APPLICATION FOR THE PLANNING CLEARANCE FOR A BUILDING PERMIT

BLDG ADDRESS: 415 BRUSH DRIVE  
SUBDIVISION: PIONEER VILLAGE SOUTH  
FILING # \_\_\_\_\_ BLK # \_\_\_\_\_ LOT # 7  
TAX SCHEDULE NUMBER:  
2945 153 03 077  
PROPERTY OWNER: JAMES BIBER  
ADDRESS: VAUST FEDERAL PARK  
PHONE: 243-8478

DESCRIPTION OF WORK AND INTENDED USE:  
OFFICE BUILDING

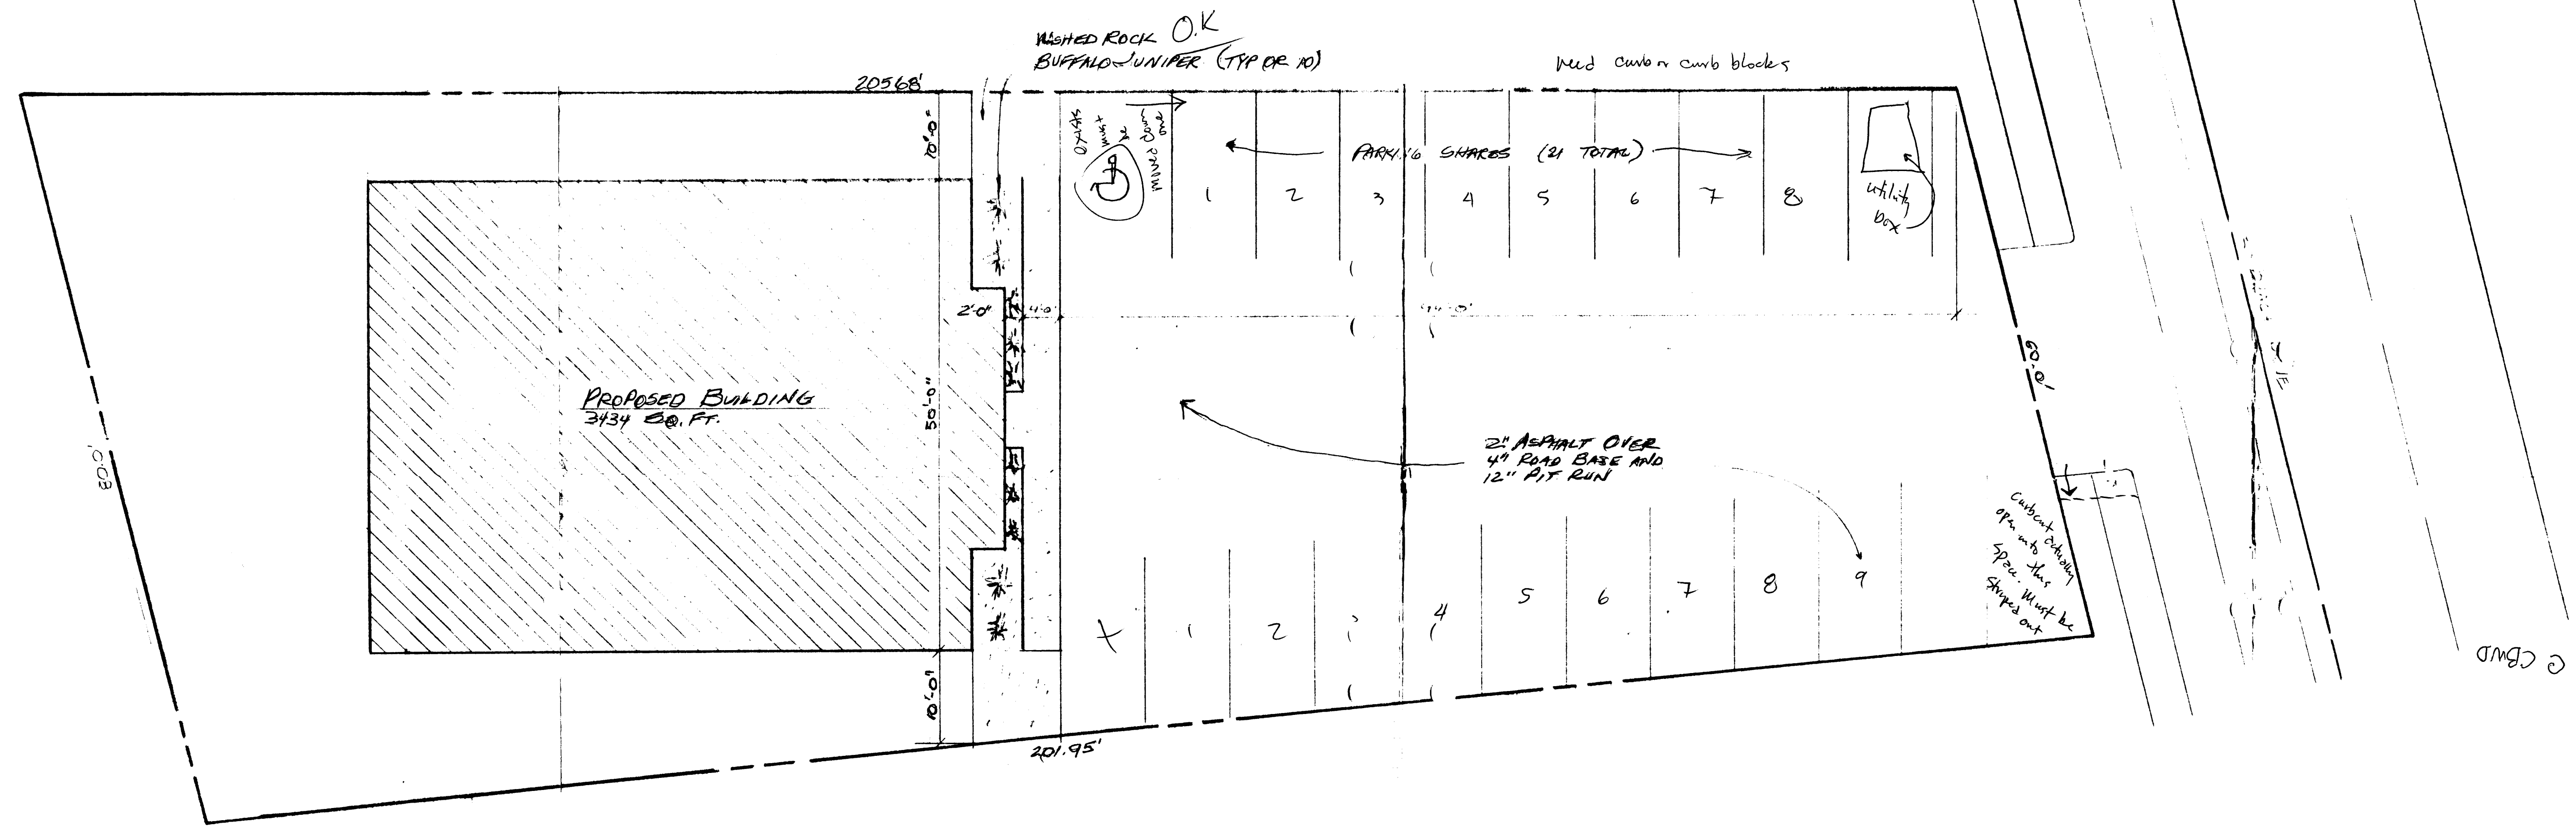
PARKING SPACES REQUIRED: 12 req. 21 provided <sup>19</sup> 2 parking spaces (AS SHOWN ON PLAN)  
LANDSCAPING/SCREENING: \_\_\_\_\_ LANDSCAPING req. (AS SHOWN ON PLAN)  
TRANSFORMER BOX - BEWARE FOR INGRESS/EGRESS. (SEE PLAN)
